Additional comments received at conclusion of the final report are addressed below.

Above: Updated North Road parking along Greenebaum property.

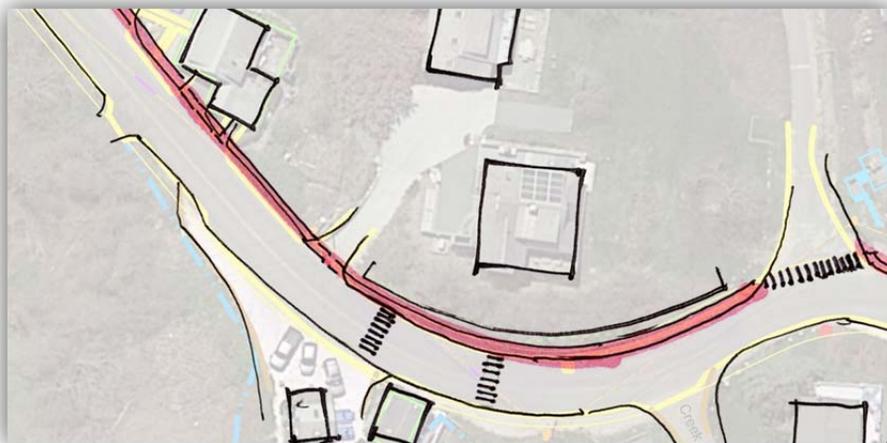
- B.0 Develop drawings showing an overview, an elevation and a section of the North Road/Greenebaum lot area developed for an additional walkway.  
*Response: Additional views of the Greenebaum property have been provided.*

Above: Cross-section through typical shell/gravel walkway

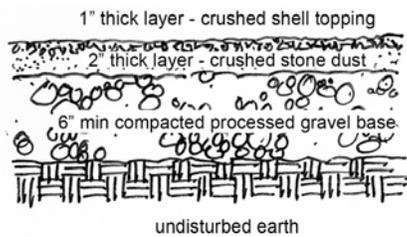
B1.1 Illustrate exactly where the shell/rock path is and where the painted areas and crosswalks are located and can you provide a very clear recommendation for the entire walkway/path in this area so that the person implementing the plan is clear on what is to be done.

B1.2 Add an additional sketch that fleshes out the Basin Road walkway so that more details could be seen.

*Response: Further definition of exactly where there is shell/gravel vs. existing pavement will require a much larger scale engineering drawing/survey to identify in the next phase.*

*Generically, wherever there is existing bituminous pavement adjacent to the roadway (i.e., parking for retail and restaurants, etc.), a simple painted path matching the shell/gravel path is proposed over the existing pavement. Discussions indicate that the painted path should be demarcated in solid gray pavement paint with a white painted edge line.*

Above: Looking west toward The Galley.

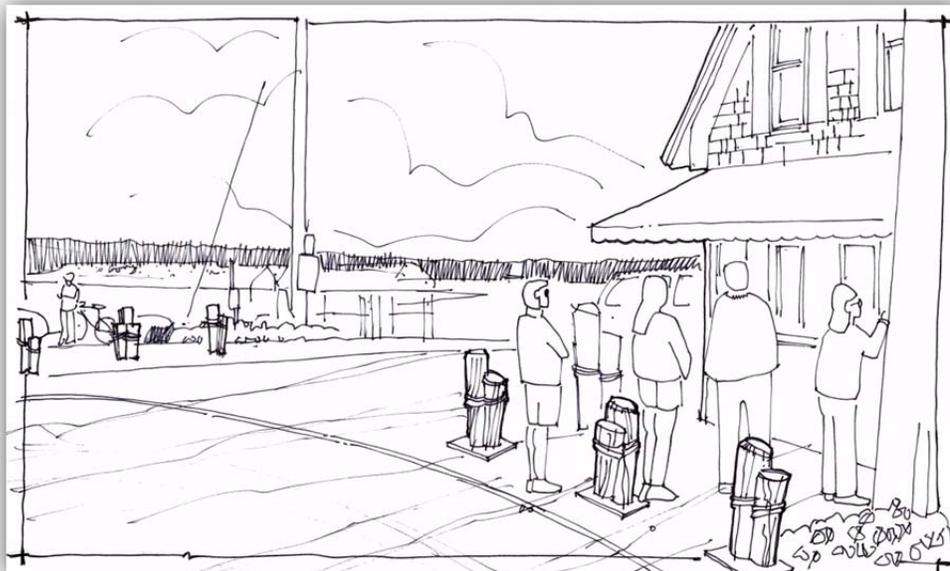
- a. Provide an additional sketch description and of the waiting area in front of the Galley.

Above: Updated vehicle and moped parking near Greenebaum parcel and bicycle racks at the Galley cul-de-sac.

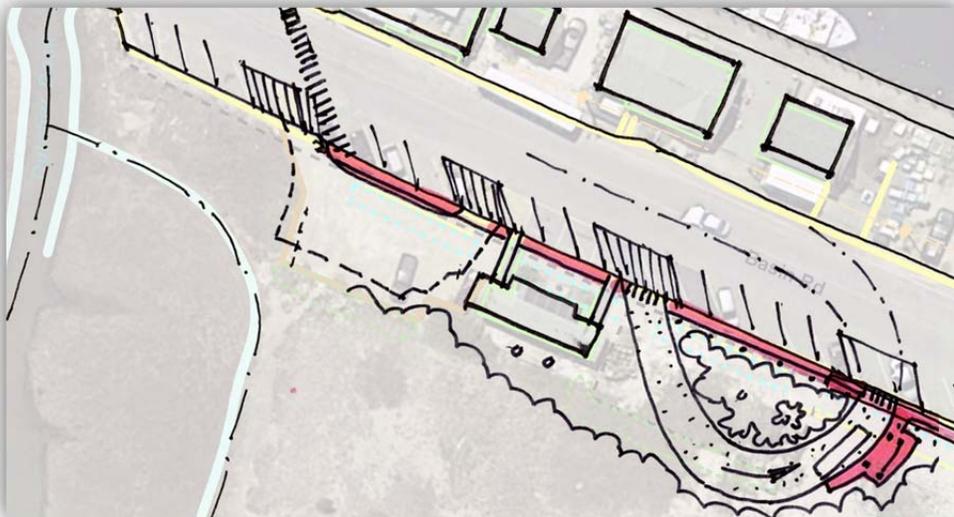
- b. Recommendations #4 & #5 do not appear to be shown on the accompanying sketch.

*Response: Refer to Greenebaum parcel update, above.*

Above: Alternative beach access on north side of headwall and break-water.

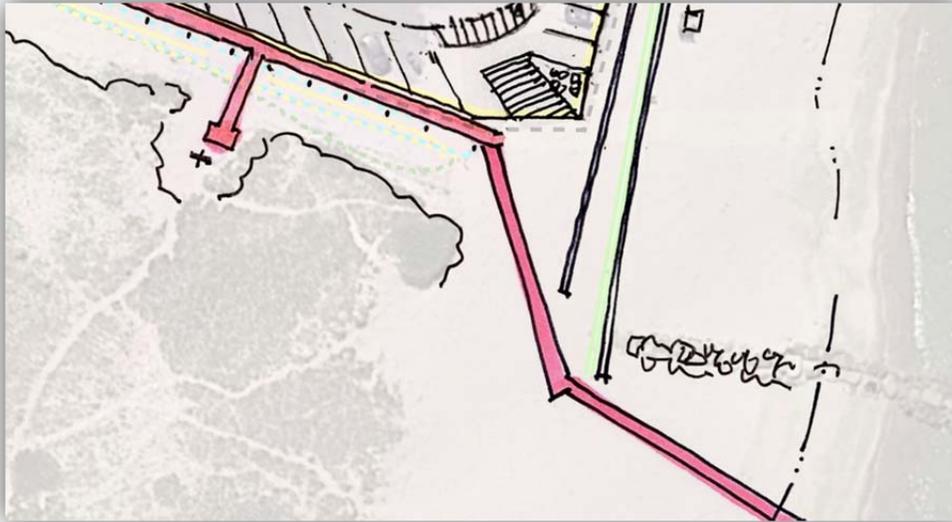
B4.1 Provide an illustration of how a person using a wheelchair or walker or other type of access vehicles would access the beach from the parking lot.  
*Response: Drawing (p. 8) Dutcher Dock to Menemsha Beach Parking shows the proposed beach access through the new and existing headwall for a fairly direct route to the waterline. Alternatively, the path can be flipped such that the bulkhead can remain as it presently is, and the path configured to the north of the breakwater to the highwater line.*
